From: Linero, Alvaro
Sent: Friday, March 20, 2009 11:51 AM
To: 'Osbourn, Scott'; Heron, Teresa
Cc: Lorne, Jacquelyn; Hathaway, Richard; Santilli, Dave; Gnecco, John
Subject: RE: RBEC -- VOC cap
Attachments: Emission Evaluation to DEP MPS.pdf

Emission Evaluation of M501G1 to DEP

**Re: Florida Power & Light Company
Cape Canaveral Energy Center Project
DEP File No. 0090006-005-AC**

**Florida Power & Light Company
Cape Canaveral Energy Center Project
DEP File No. 0090006-005-AC**

Fig-1: Measured NOx and CO at T-Point

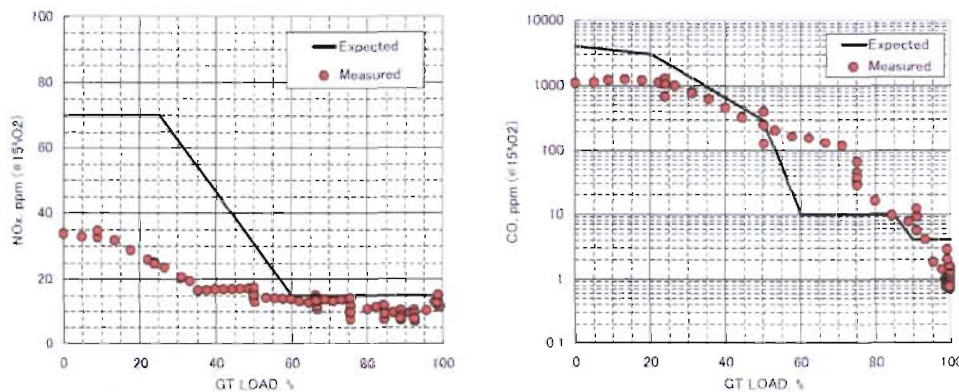
As shown on Fig-1, measured NOx emission is in line with the expected value, but CO emission exceeds the expected values between 50% and 90% load because operating settings optimization was not required during this load range for the T-point.

In order to achieve the expected CO emissions between 50% and 90% load, firing temperature have to be increased by changing IGV opening settings as follows;

- (1) IGV setting is changed towards closed position at each load between 50% and 90% load
- (2) Firing temperature is increased by reducing inlet air flow with IGV more closed
- (3) CO emission can be decreased by firing temperature increase.

Fig-2: Measured CO vs. Firing Temperature

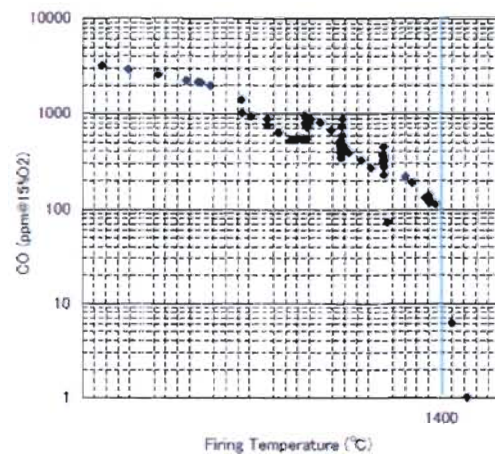
CO emission value to each firing temperature have been already measured and confirmed in actual operating experiences as shown on Fig-2.

Fig-3: GT Load vs. Firing Temperature

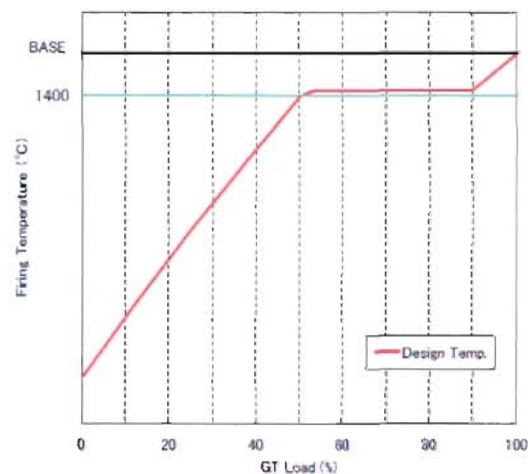
Therefore, CO emission can be achieved to the expected values by means of firing temperature increase above 1,400 deg.C with IGV setting optimization between 50% and 90% load as shown on Fig-3. NOx emission during part load can be still kept to the range not exceeding the expected values by pilot fuel ratio adjustment, although the firing temperature increases.

Fig.-4: CO vs. VOC on oil firing at Rig Test

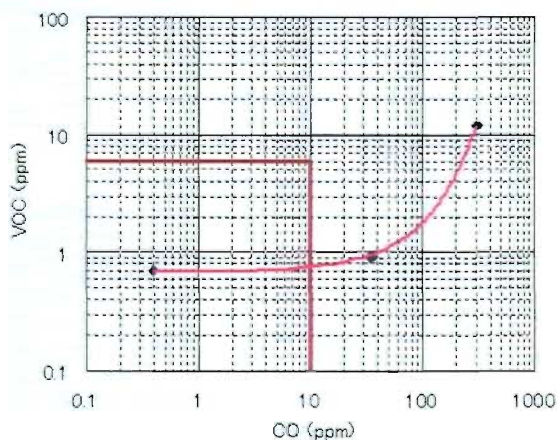
But note that (according to Mitsubishi) as long as CO is kept to less than 10 ppm, then VOC is expected to be less than 1 ppm. They felt safe for purposes of guarantees setting it a 6 ppmvd @15% O2. Again, even here I'm not sure they mean VOC excluding the methane.

- VOC will be less than 1ppmvd in case that CO emission is 10ppmvd or below as shown on Fig.-4.
- Formaldehyde will be less than 91ppbvd in case that CO emission is 10ppmvd or below as shown on Fig.-5.

Therefore, we are confident to achieve the above guaranteed values, however, above is the figures to be guaranteed taking into consideration of measurement uncertainty, etc.
